Correspondence Received in Opposition to the Paved Paths Component of the Proposed Arana Gulch Master Plan

Individual Correspondence:	56 letters
Form Letter Correspondence: (Includes three types of form letters)	39 form letters
Total:	**95 letters**

Re: Thursday, March 11, 2010
Item 7.a. Application No. 3-09-068 (City of Santa Cruz) Arana Gulch Master Plan

Arana Gulch
MASTER PLAN EIR
SANTA CRUZ TARPLANT AREAS 1989
Figure 4.2-3a

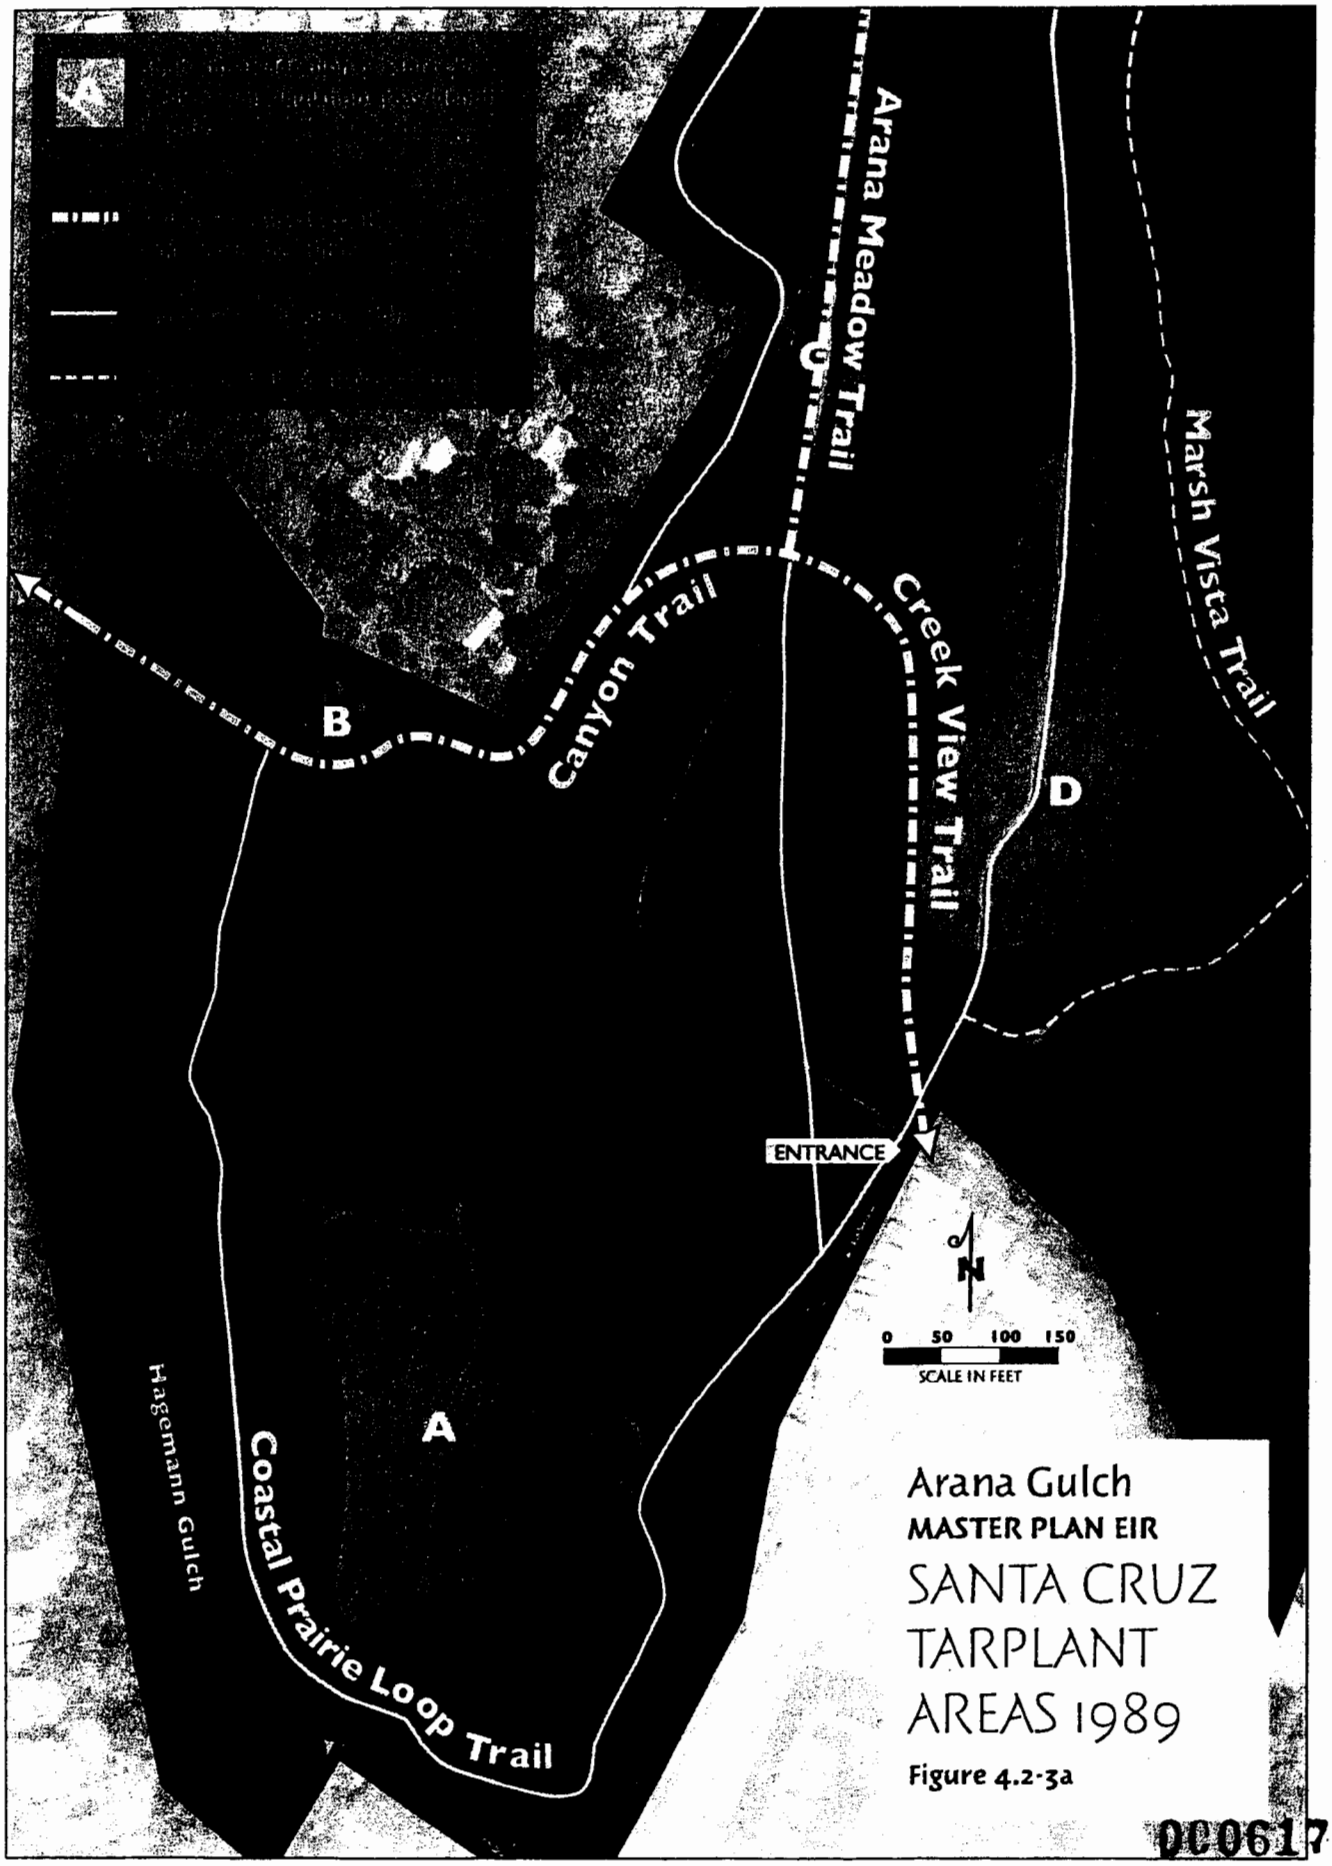
The multi-use trails avoid recently-mapped tarplant populations in Areas A and D. As shown in the attached Figure 4.2-3a, the multi-use trail alignment fully avoids the largest recent and historic tarplant Subpopulation Area A, which is located within the southern portion of the meadow. The 2004 survey identified 797 plants and the 2005 survey identified 1,552 plants. Previous surveys undertaken from 1996 through 2003 found populations ranging from 619 plants to approximately 65,000 plants in 1998. The proposed paved multi-use trail is located no closer than 400 feet from the 2004 and 2005 mapped tarplant within Subpopulation Area A (see amended Figures 4.2-4 and 4.2-5 attached). The trail alignment was proposed and designed to the furthest north to ensure subpopulation Area A is fully protected in its entirety and not degraded.

The paved multi-use trail would avoid Area B that is about 3,600 square feet in area and would pass through Area C that is about 12,000 square feet in area (see amended Figure 4.2-3a attached). However, these mapped areas are very generalized since the mapping was done without the accuracy of GIS or GPS as explained earlier.
